Submission/Opposition - WHTBL

Figure 8-10 Modelled discrete receptor locations and construction footprints

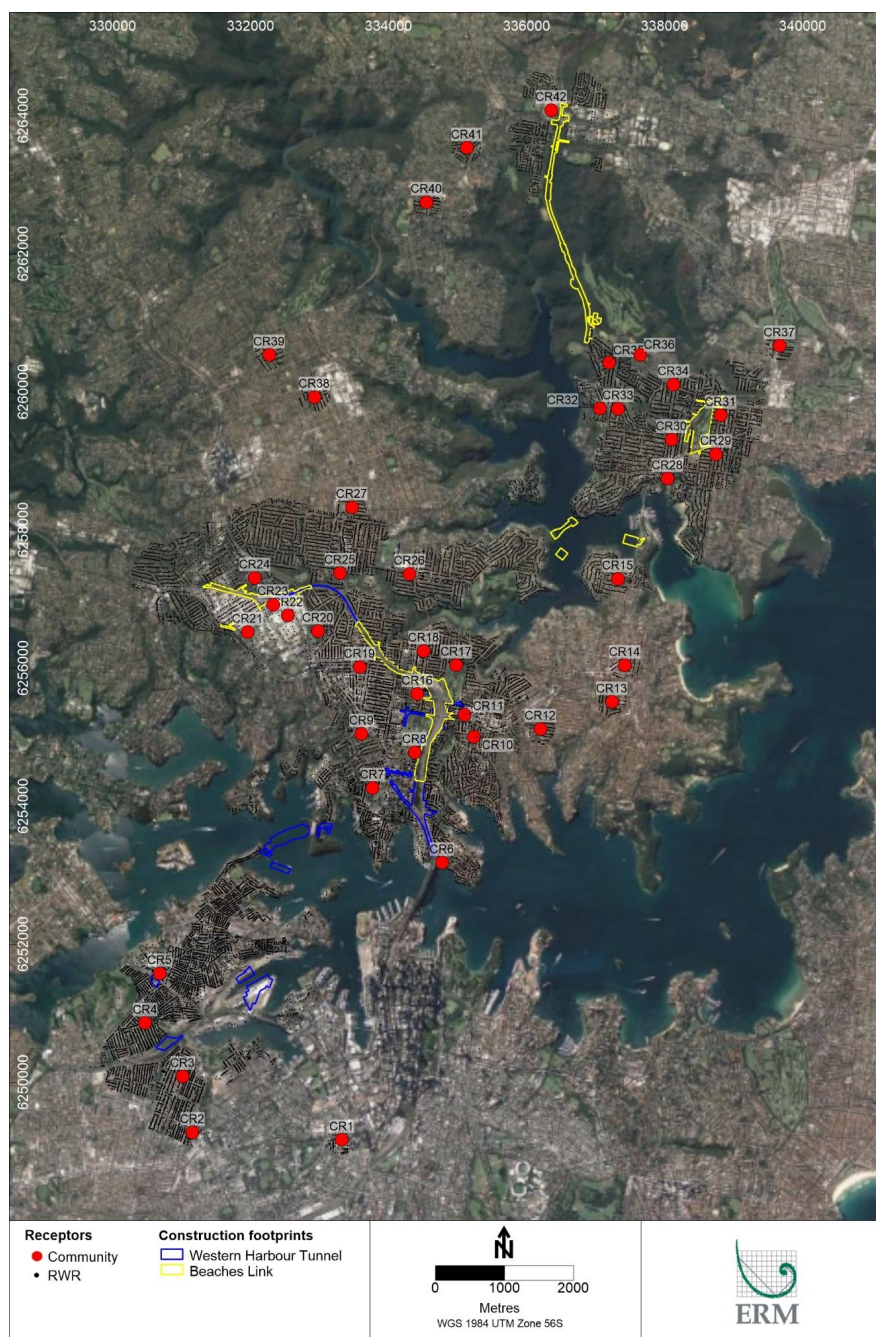
The 42 modelled sites detailed in figure 8-10 are not at all representative of the overall set of Sensitive Receptors. The greatest density of adversely impacted Sensitive Receptors have been completely excluded from the air quality and human health modelling, while Sensitive Receptors far outside the stated 500-600m distance from the project have been included....

The modelling has also included Sensitive Receptors that lie far outside the stated 500-600m distance from the project zone. These include Willoughby Public School (around 1300m from the project zone), as well as Mosman Public School and Roseville Public School (both around 2400m from the project zone).

By excluding the greatest density and proportion of Sensitive Receptors in close vicinity to the project zone from all air quality and health modelling, while at the same time including Sensitive Receptors far away from the project zone, the EIS presents a completely distorted picture of the likely adverse impacts of the project.

Requested Action: All Air Quality modelling, analysis, and assessments by the Chief Health Officer should be redone so as to: (A) include all Sensitive Receptors in the area bounded by Miller Street, Ernest Street, and the Pacific Highway inclusive (within the “purple cloud” in figure I-45 that shows an increase in PM2.5), and (B) exclude all Sensitive Receptors that are more than 1000m from the project footprint. This should be made available to general public for review and comment prior to formal assessment of the EIS commencing.

Figure I-45 Contour plot of change in annual mean PM_{2.5} concentration in 2027 cumulative scenario (all sources, 2027-DSC minus 2027-DM)

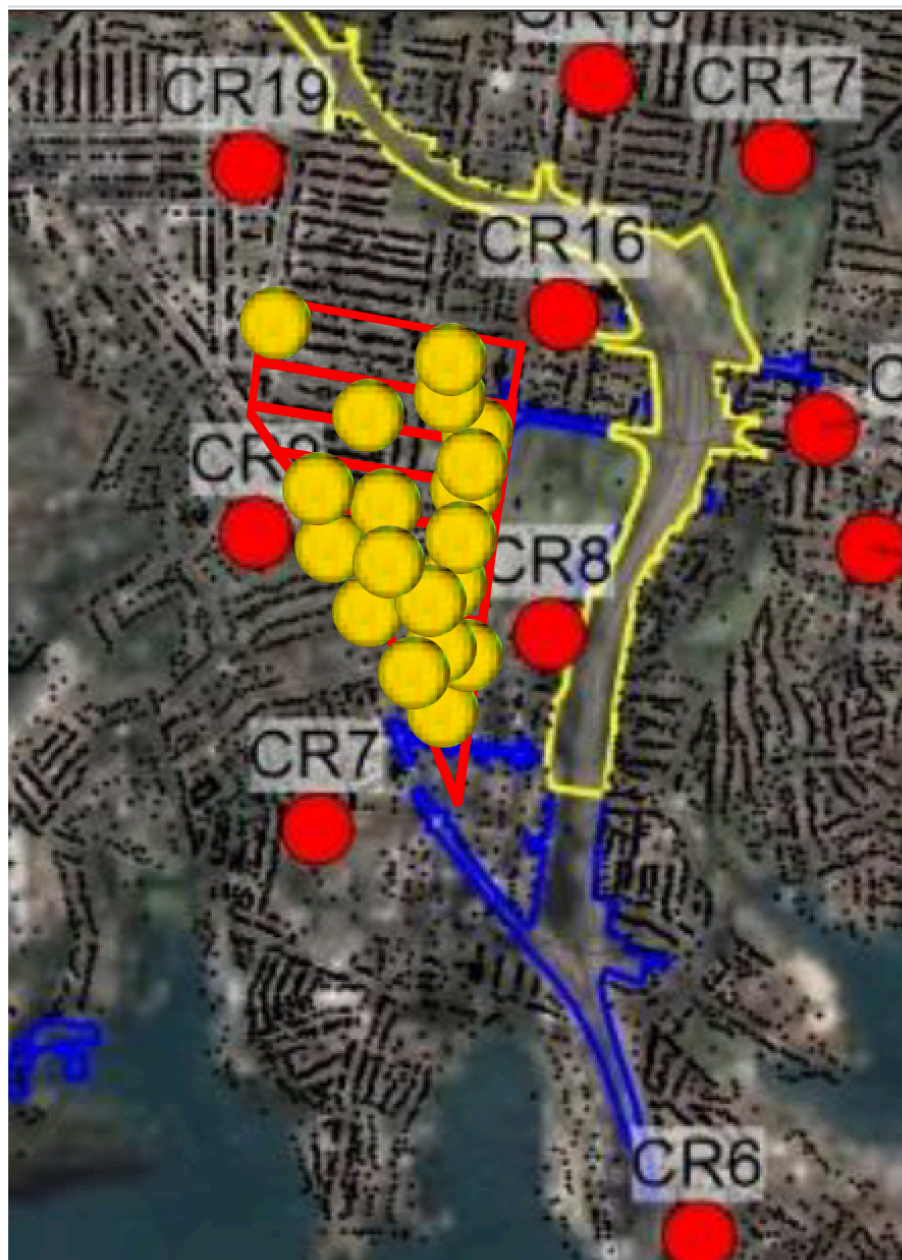
The area bounded by Ernest Street, Miller Street, and the Pacific Highway in the North Sydney LGA contains the one of the highest concentration of childcare and kindergartens per m2 anywhere in Australia, the highest concentration of primary schools per m2 anywhere in Australia, as well as the highest concentration of secondary schools per m2 anywhere in Australia. Together, this area that has been excluded from all air quality and health impacts modelling represents more than 50% of all school students and childcare and kindergarten attendees in the locally impacted area. (Source: www.myschool.edu.au) The schools include: St Mary’s Primary, Cammeraygal High School, North Sydney Boys High, North Sydney Girls High, Marist College, St Angelo Mercy, and North Sydney Public School. All of these Sensitive Receptors appear to be adversely impacted by an increase in PM2.5 as is indicated in figure I-45 from the Air Quality Appendix.

Cumulative Increase in PM_{2.5}. Note: the purple “cloud” covering the area bounded by Miller Street, Ernest Street, and Pacific Highway.

Note: all Sensitive Receivers in the area bounded by Miller Street, Ernest Street, and Pacific Highway have been excluded from modelling, despite this student population representing over 2/3rds of the total in the area.

Area excluded from Air Quality and Human Health impacts modelling.

Sensitive Receptors (19 in total) excluded from Air Quality and Human Health impacts modelling, representing over 2/3rds of all school students and child care attendees in the area.
